THE CITY OF SAN DIEGO

REPORT TO THE PLANNING COMMISSION

**DATE ISSUED:** July 3, 2008 **REPORT NO.** PC-08-077

**SUBJECT:** APPEAL OF LA JOLLA SHORES LIFEGUARD STATION  
AMENDMENT - PROJECT NUMBER: 146179. PROCESS THREE

Figure C

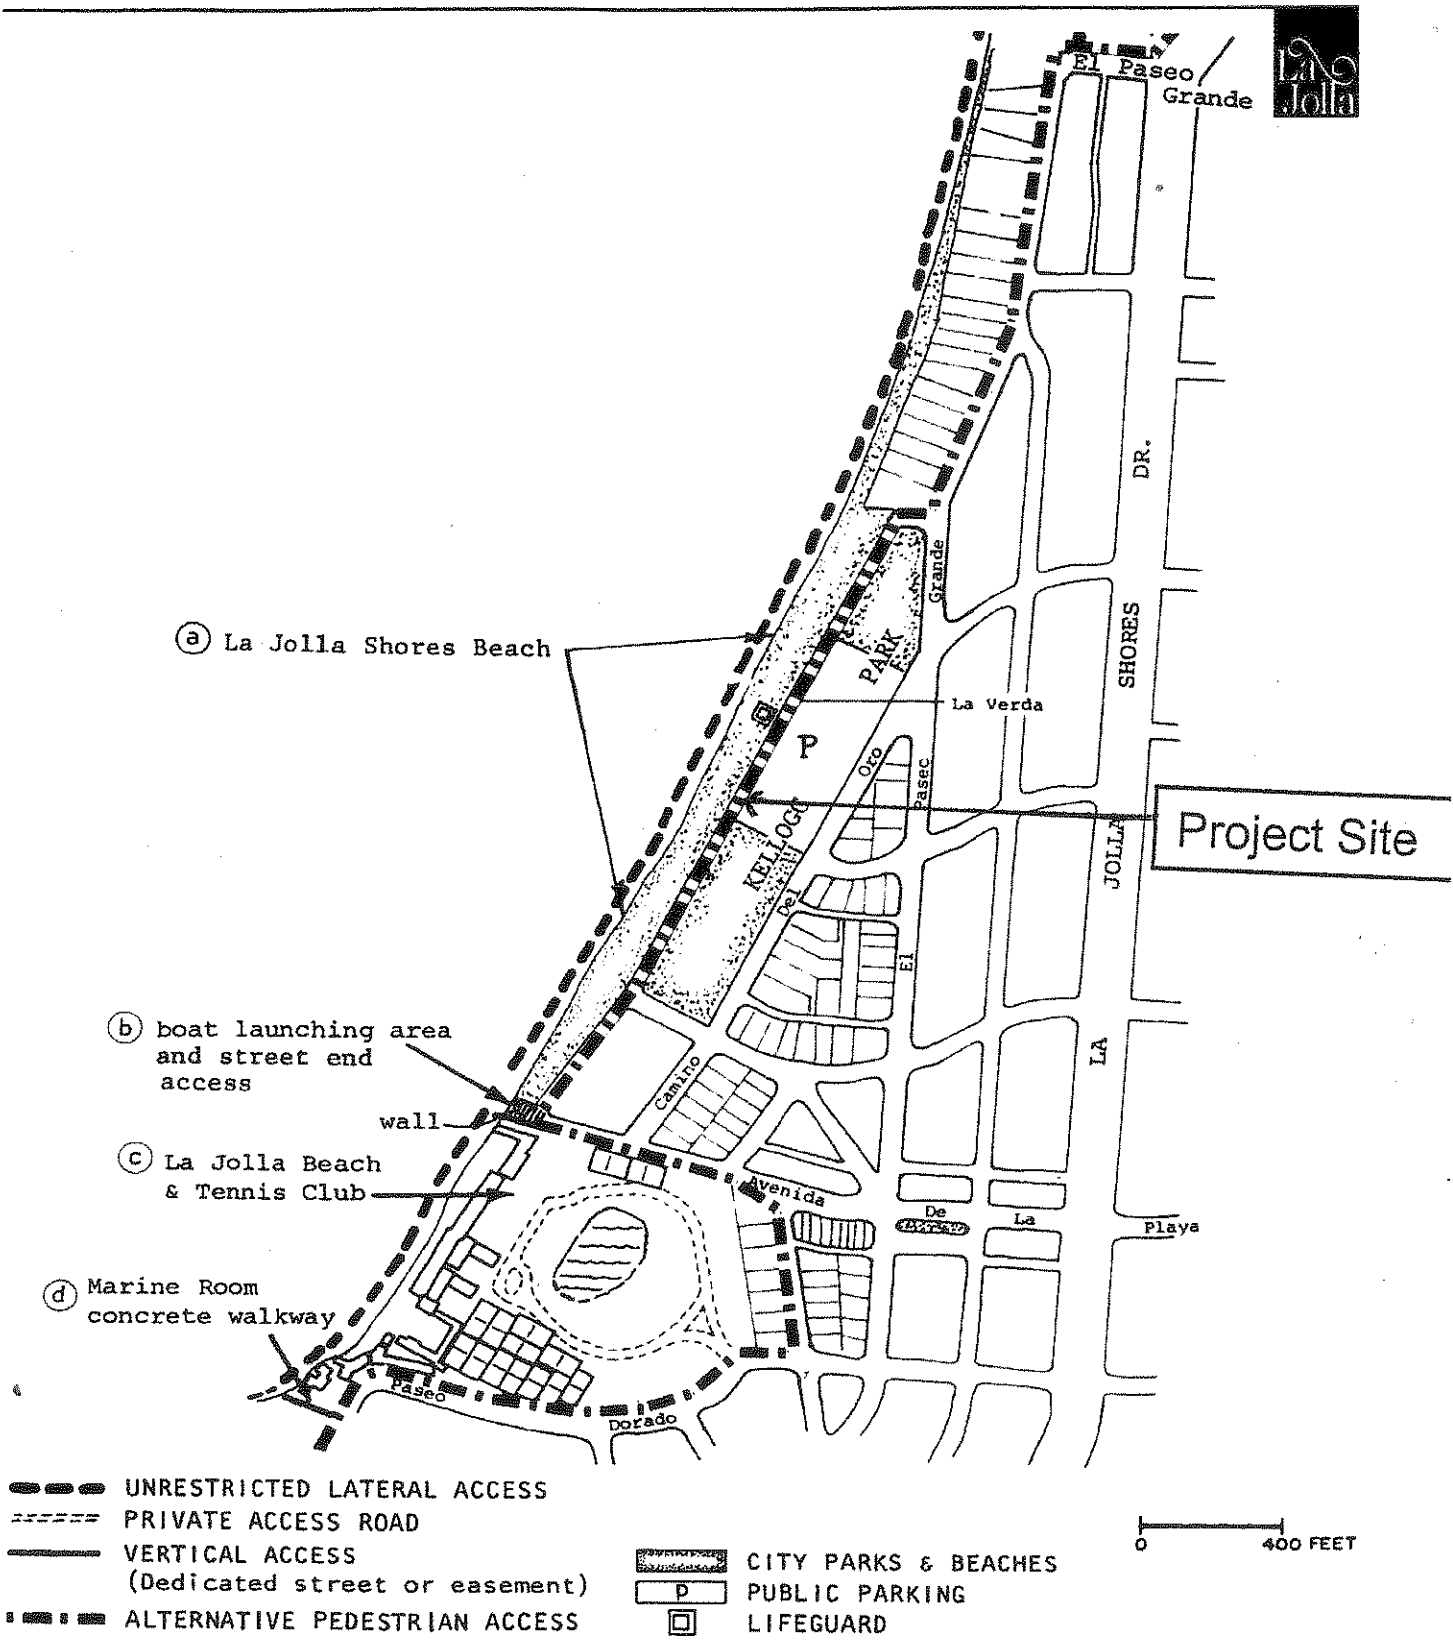
9. Figure 9, *Identified Public Vantage Points of the La Jolla Community Plan and Local Coastal Program Land Use Plan* identifies Camino Del Oro as a "Road from which coastal body of water can be seen". The proposed lifeguard vehicle storage building to be located within the existing parking lot together with the proposed lifeguard tower

building neither preserve nor enhance the public view from the roadway because together their facades are broader than existing lifeguard tower building façade. As such, the combined facades of the proposed structures will obstruct the view of the coast line from the first public roadway (Camino Del Oro) to a greater extent than the existing lifeguard tower building. The proposed lifeguard facility will actually reduce the public view of the ocean. Clearly, the proposed lifeguard tower building and the vehicle storage building conflict with the goals and policies of the La Jolla Community Plan and Local Coastal Program Land Use Plan. The analyst's conclusion is simply incorrect.

**Staff Response:** Analysis of the public views and vantage points identified in the La Jolla Community Plan and Local Coastal Program Land Use Plan (page 145 - Figure C, Attachment 16) resulted in no substantial view blockage. As previously stated above, the view from Kellogg Park is being enhanced as the existing lifeguard tower will be demolished providing expanded ocean views from the grassy park area. The new lifeguard tower will be located north of the park area and would not compromise any identified views outlined in the plan.

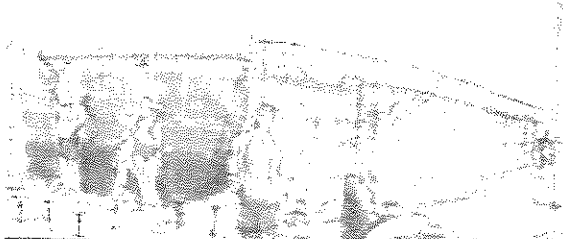
Placement of the Garage in the middle of the parking lot poses serious safety hazards for pedestrians, unnecessarily increasing costs for construction and removing much-needed parking spaces. The City's solution is to restripe the parking lot and make the spaces smaller! The cost-effective and functional solution is to spread the tower buildings apart an additional 10' so the vehicles can be parked there at night, giving the Lifeguards a larger working space during the daytime. Roll-up garage doors and roofing that is retractable would provide a sense of openness during the daytime and security for their vehicles at night.

# New Lifeguard Tower in FLOOD ZONE

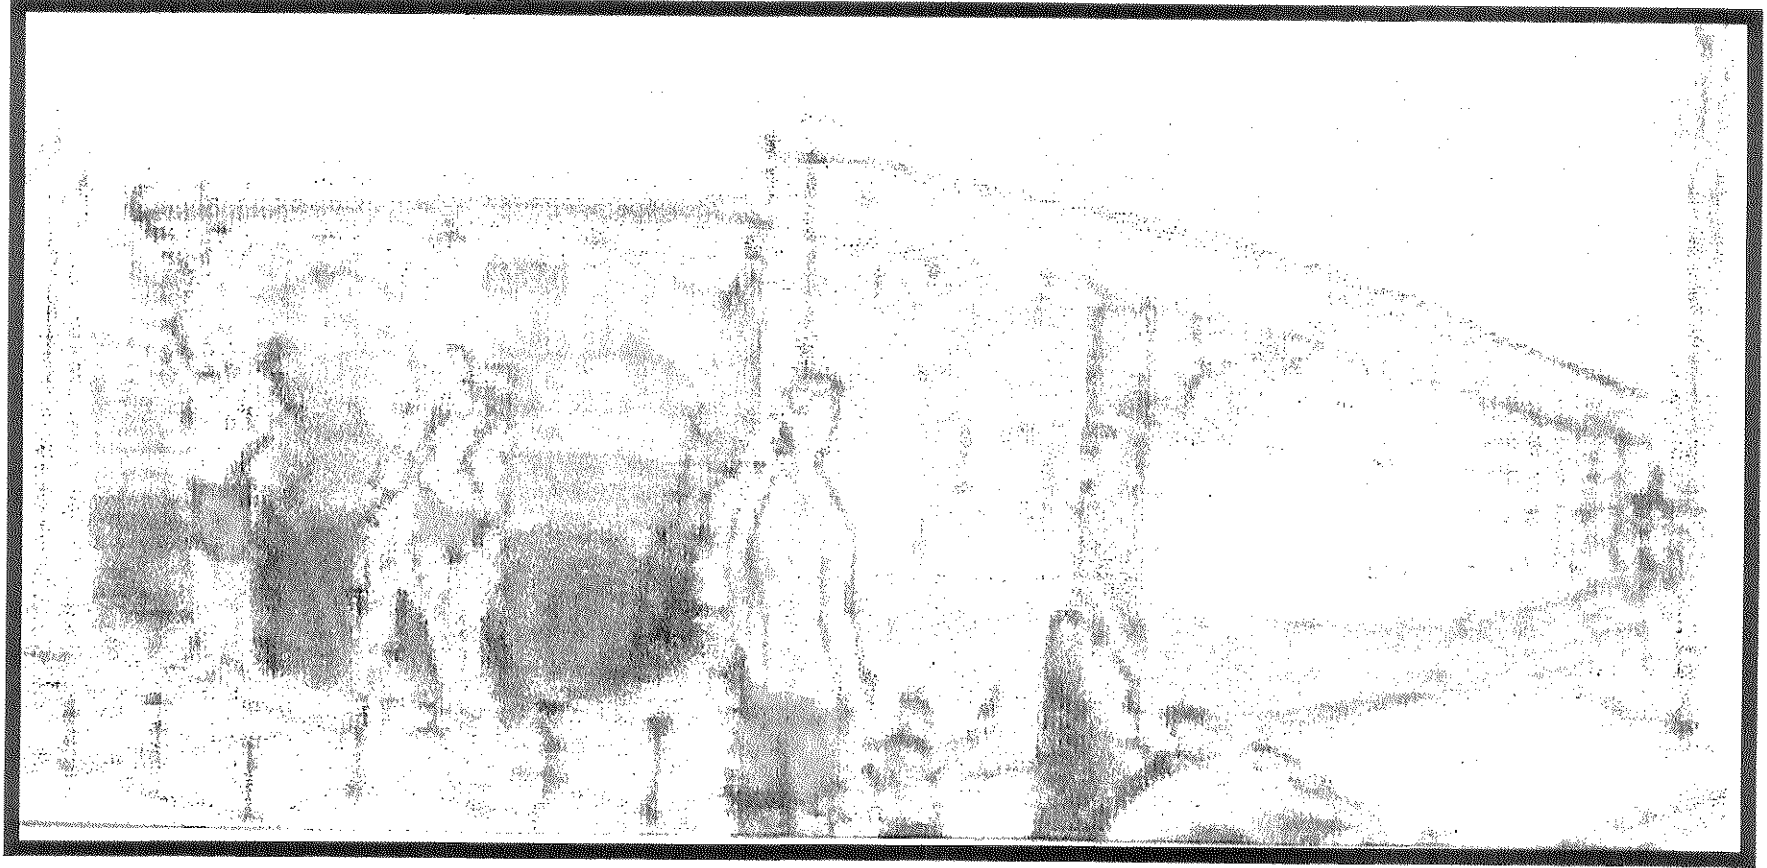
The Lifeguard Tower is being built in a flood zone. Buildings constructed today should be environmentally friendly and incorporate solar power for optimum efficiency.
